Final Drainage Report

Amendment No. 1

Beacon Lite Road Stockpile

EDARP File No. CDR261

DETENTION BASIN STAGE-STORAGE TABLE BUILDER

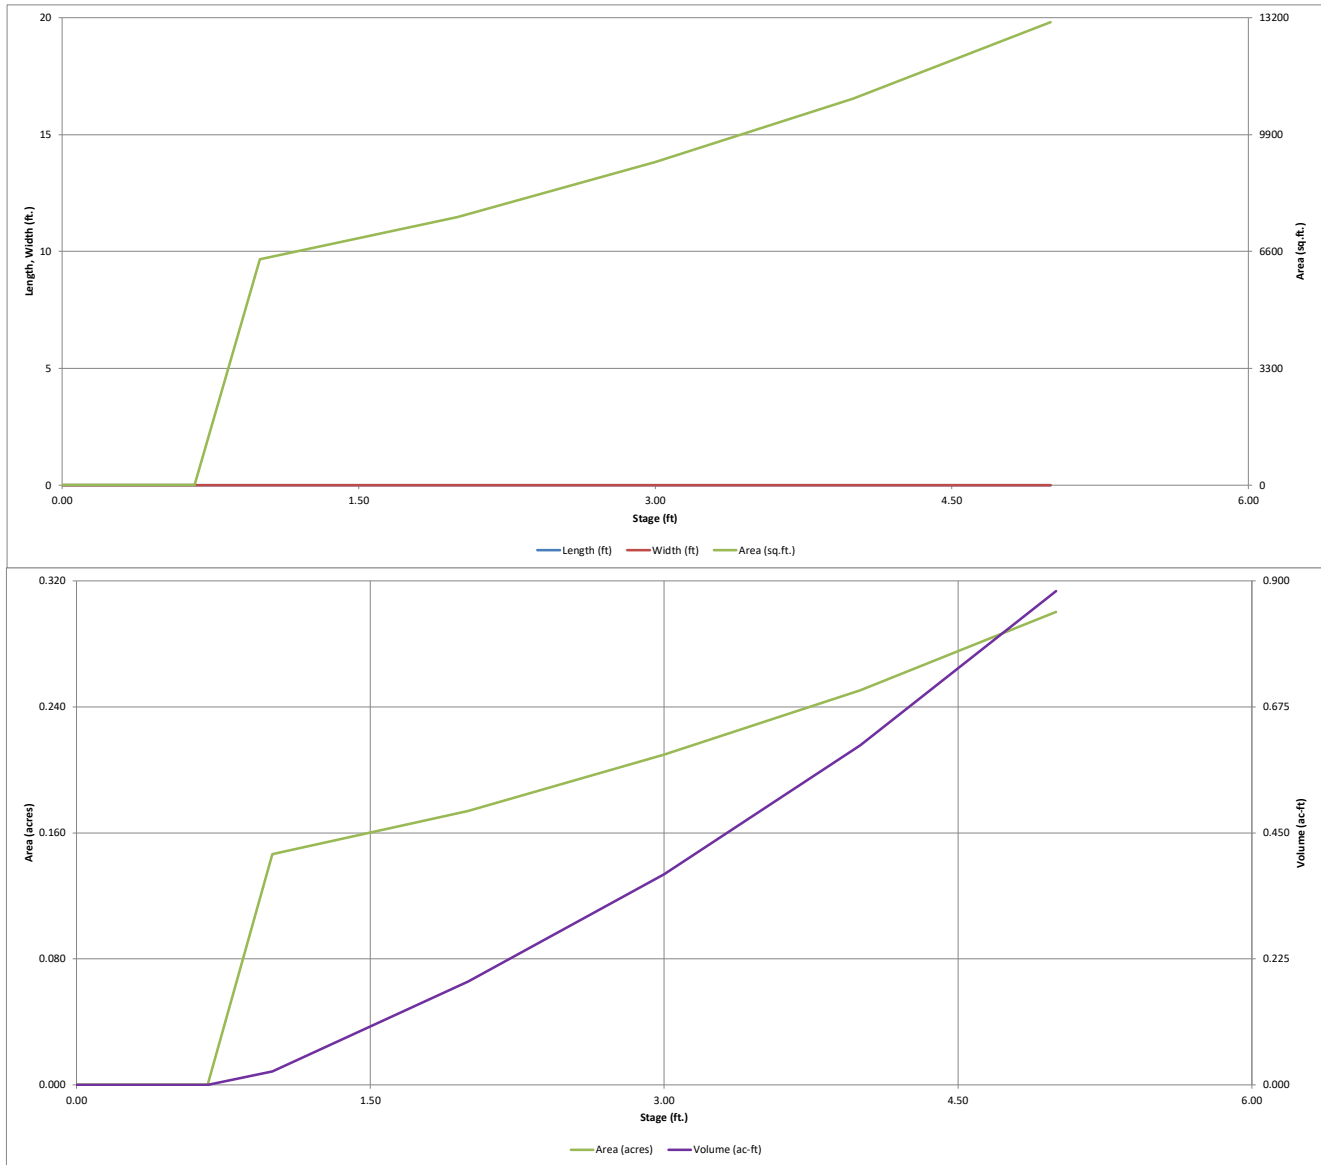
label as "amended" like you did with the revised plan sheets.

DETENTION BASIN OUTLET STRUCTURE DESIGN

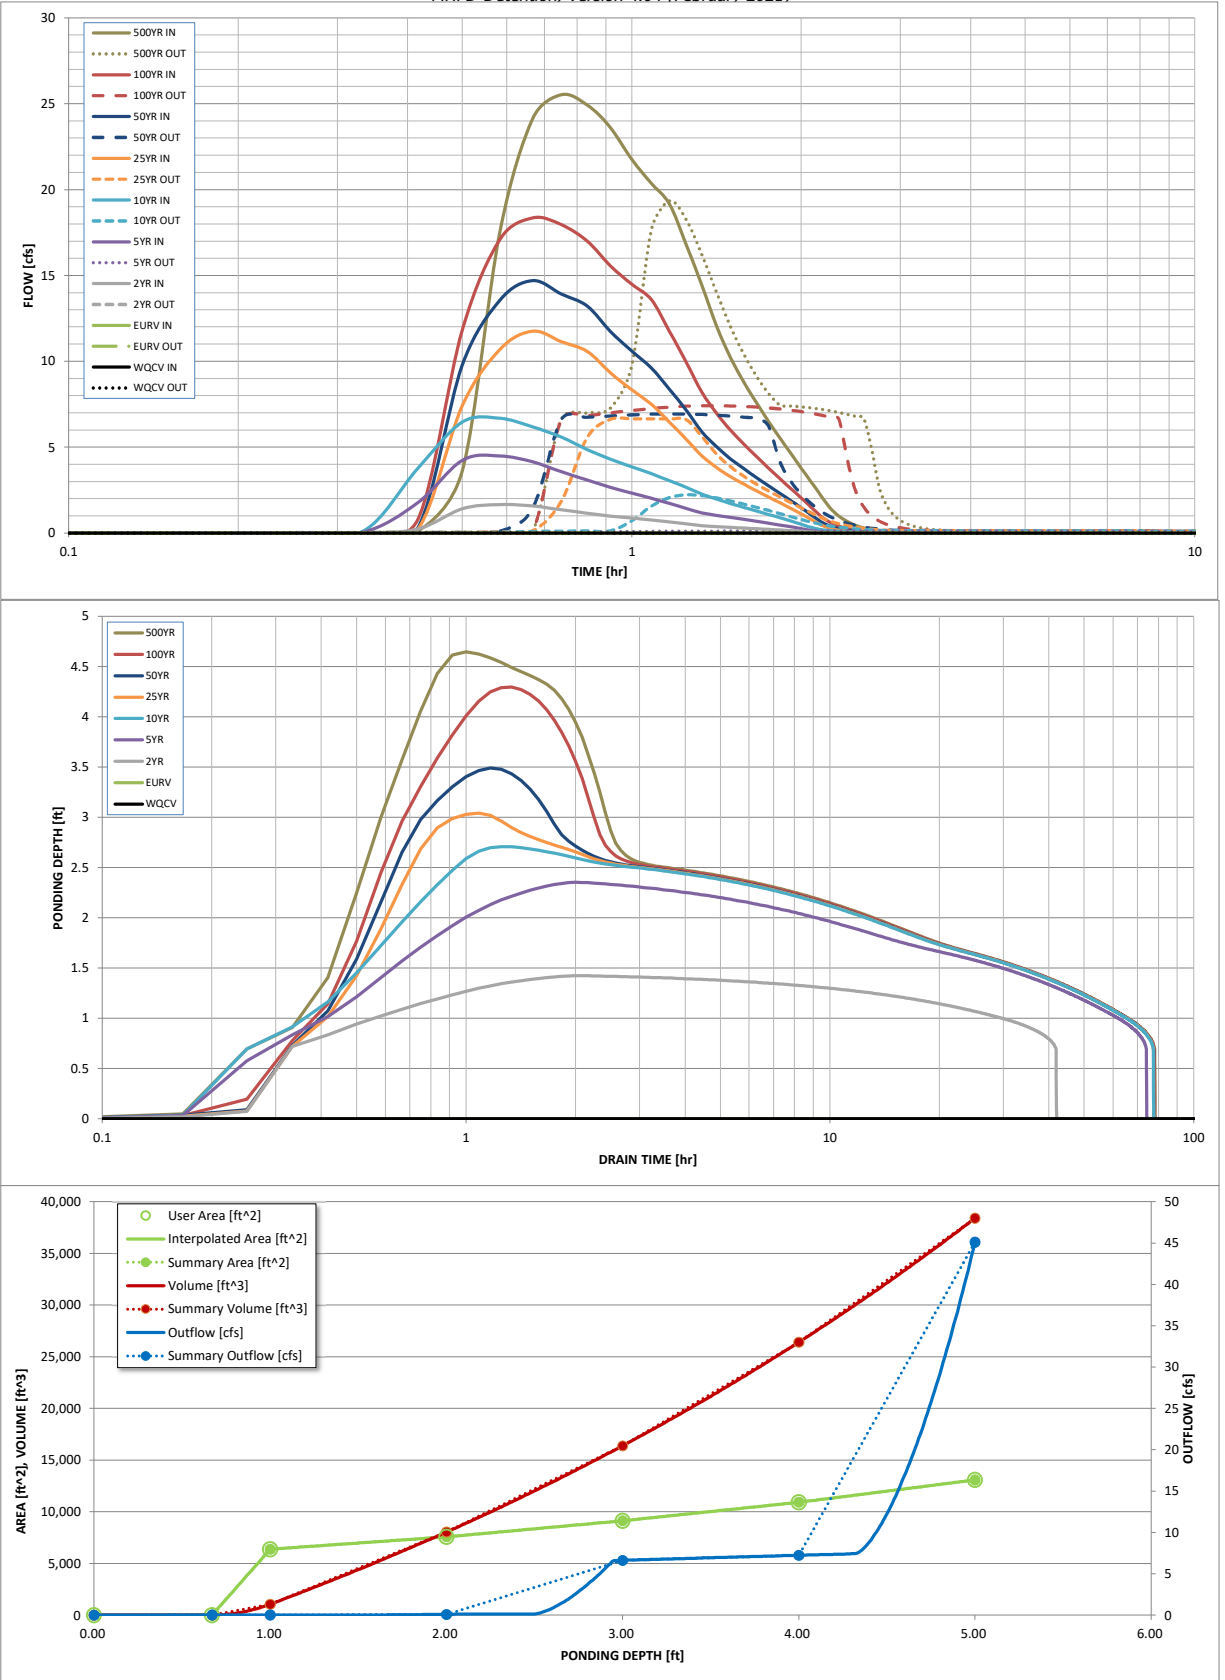
This is very confusing to have both the original Pond A calcs and the new Pond A calcs on here with no labels for clarification. Please clearly label everything accordingly. Or just completely remove the original/old calcs. Those are obsolete at this point and are memorialized in the original FDR. No need to include old stuff in here.

DRAINAGE PLAN:
EXISTING CONDITIONS - OVERALL

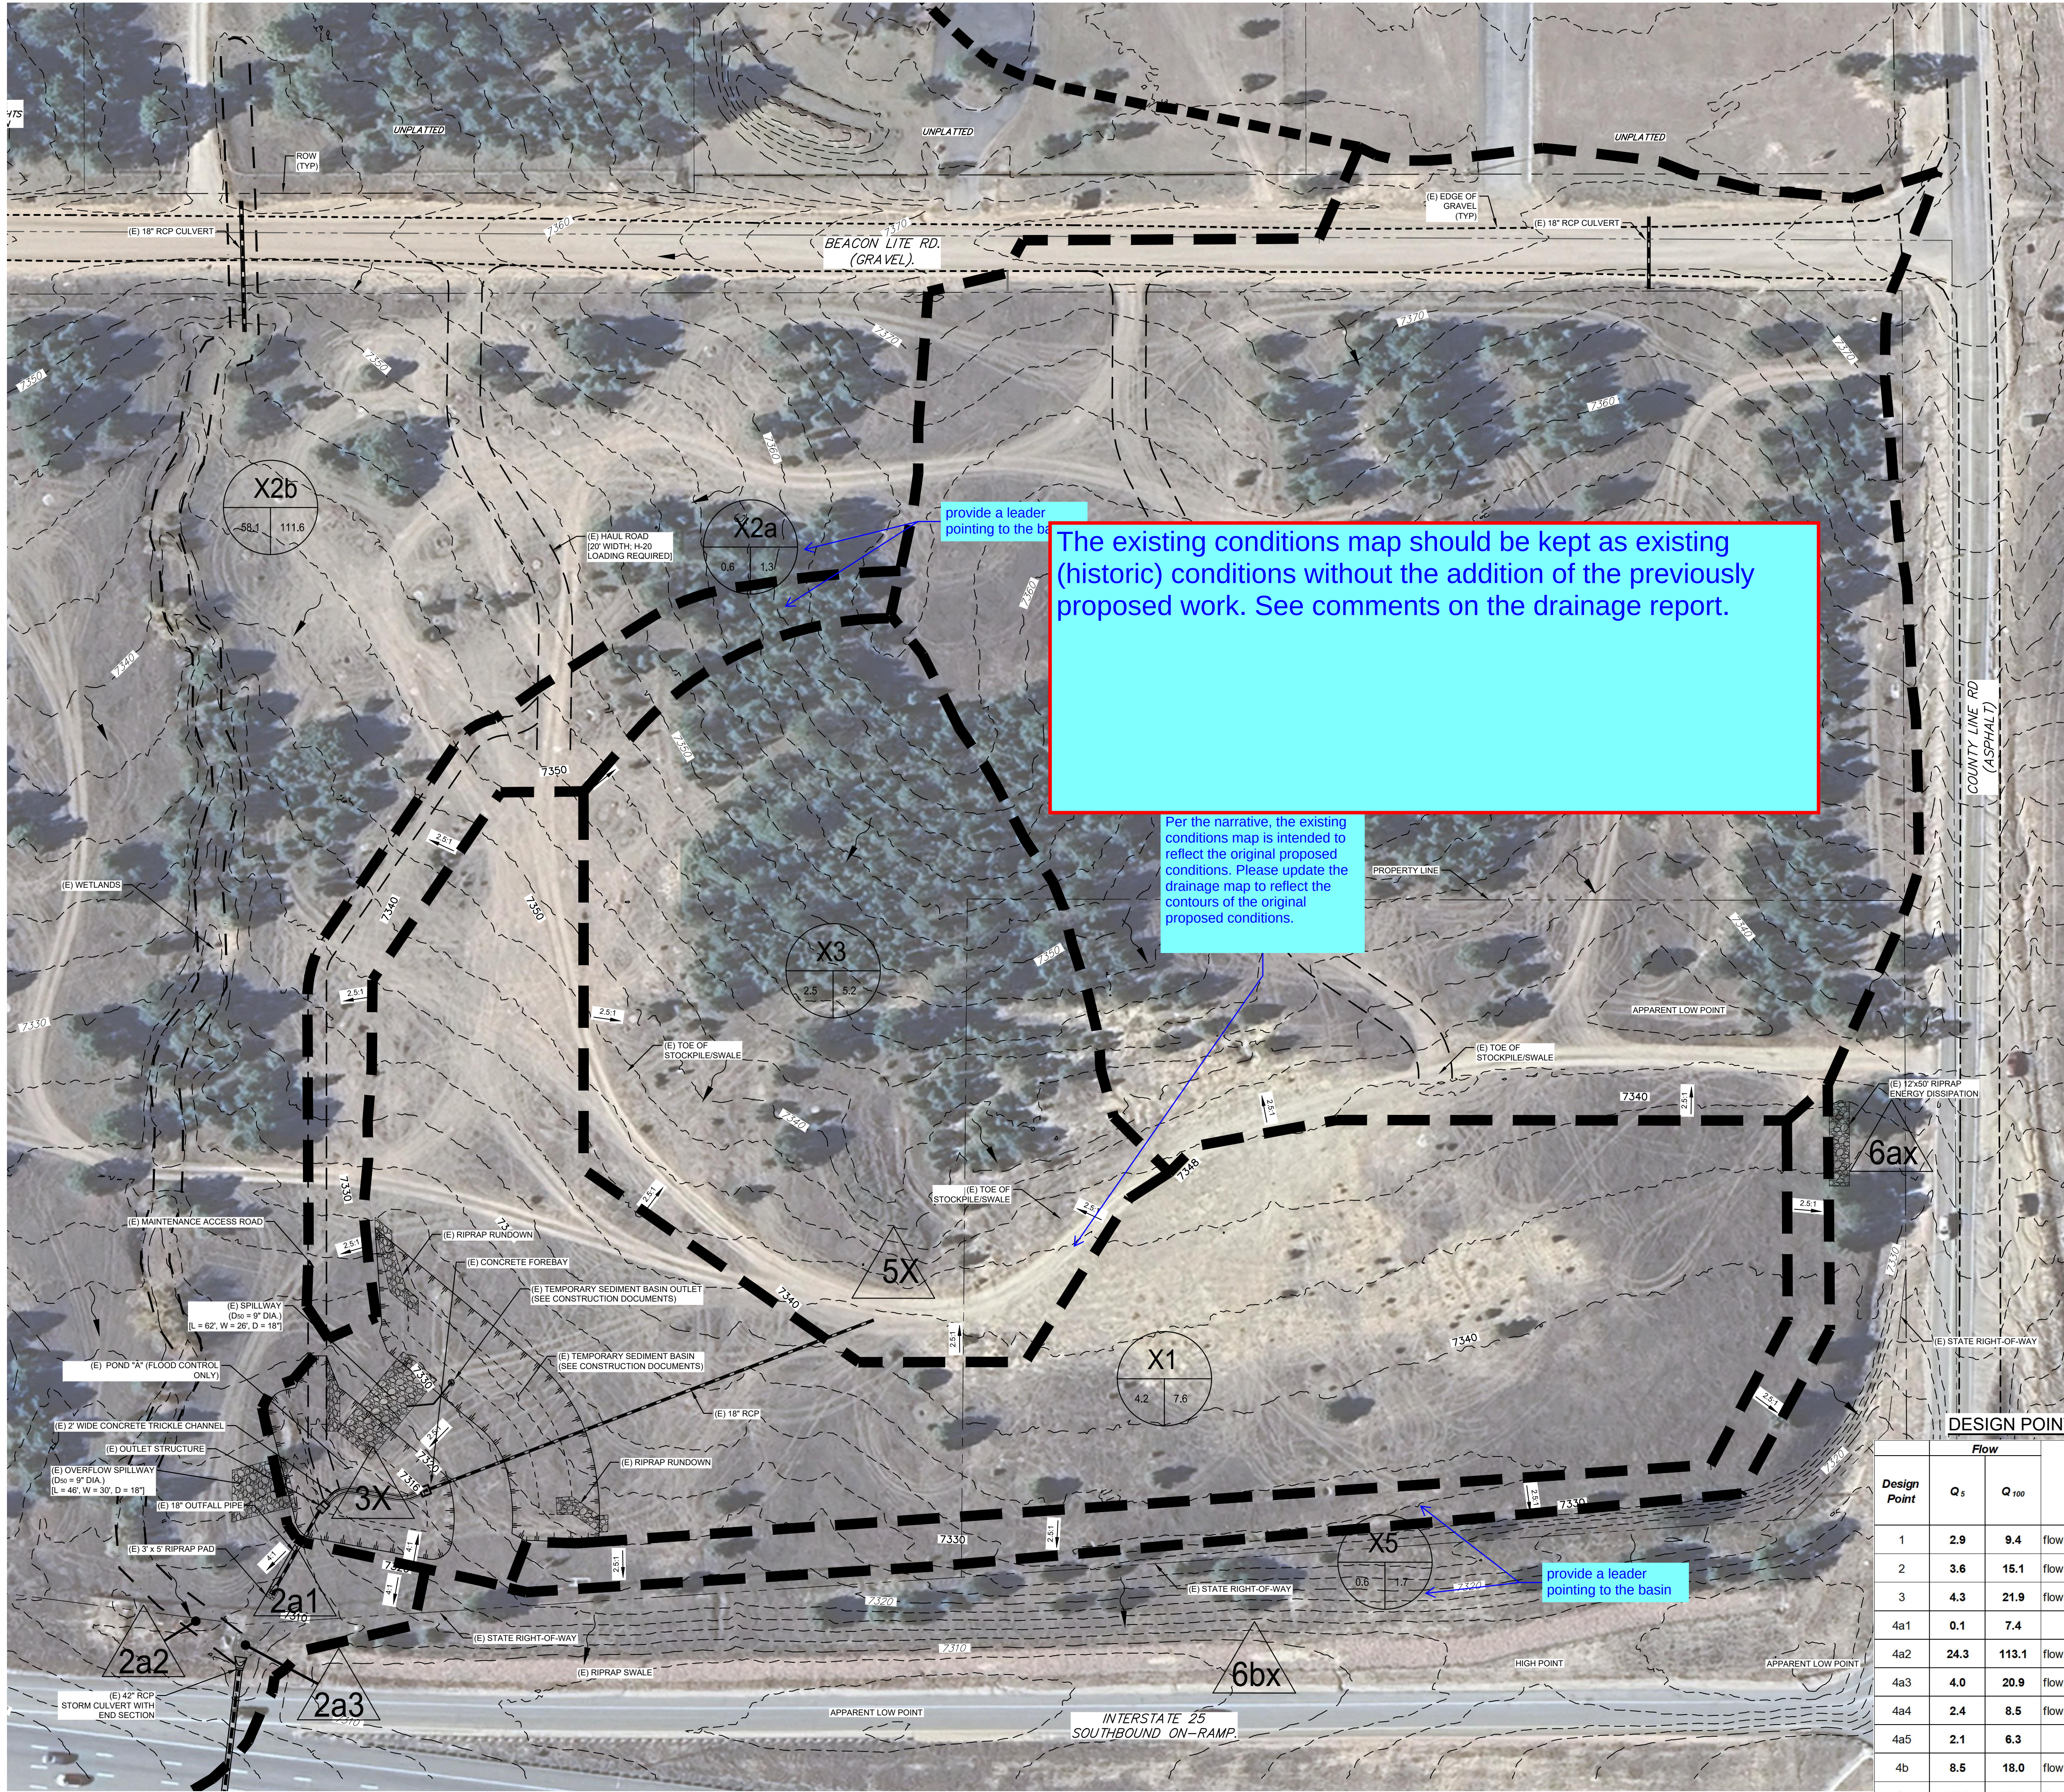
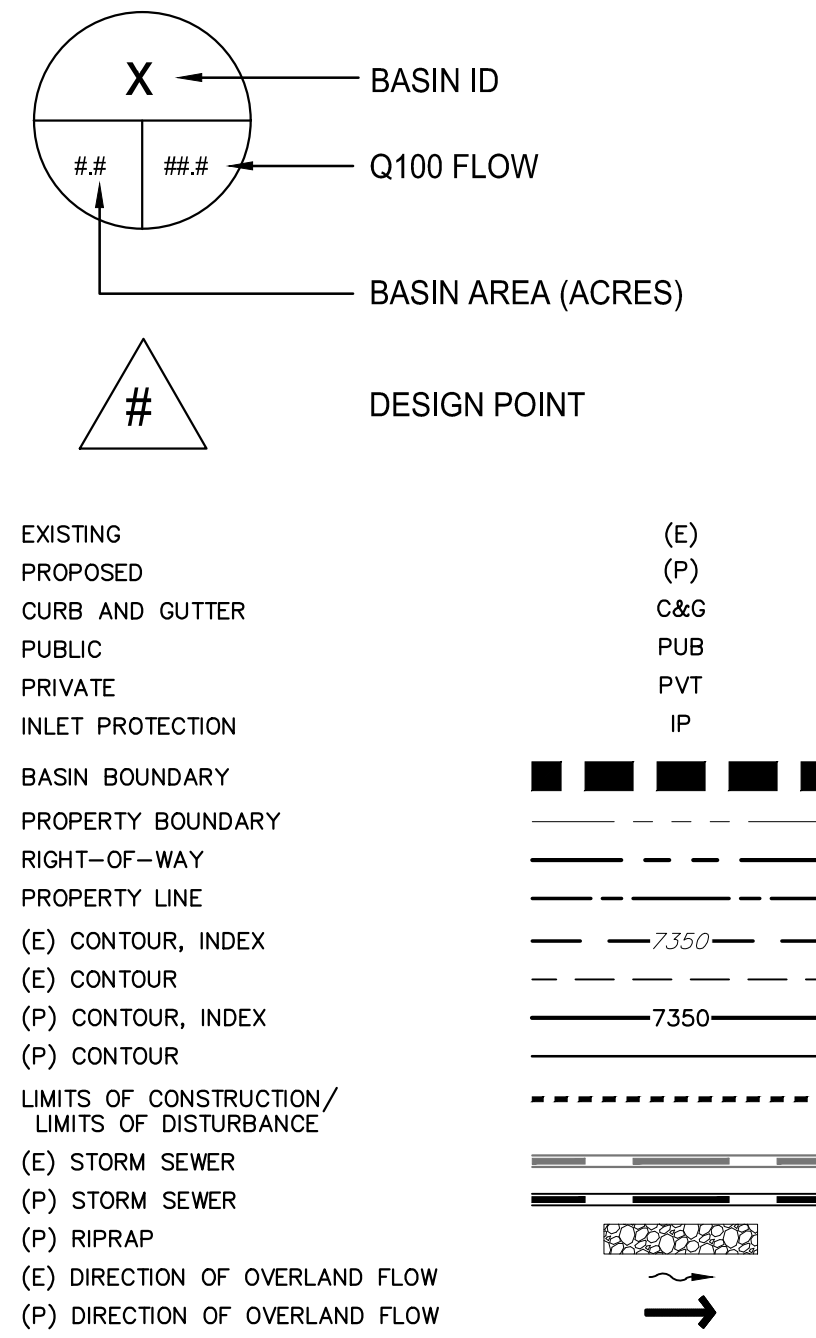
The existing conditions map should be kept as existing (historic) conditions without the addition of the previously proposed work. See comments on the drainage report.
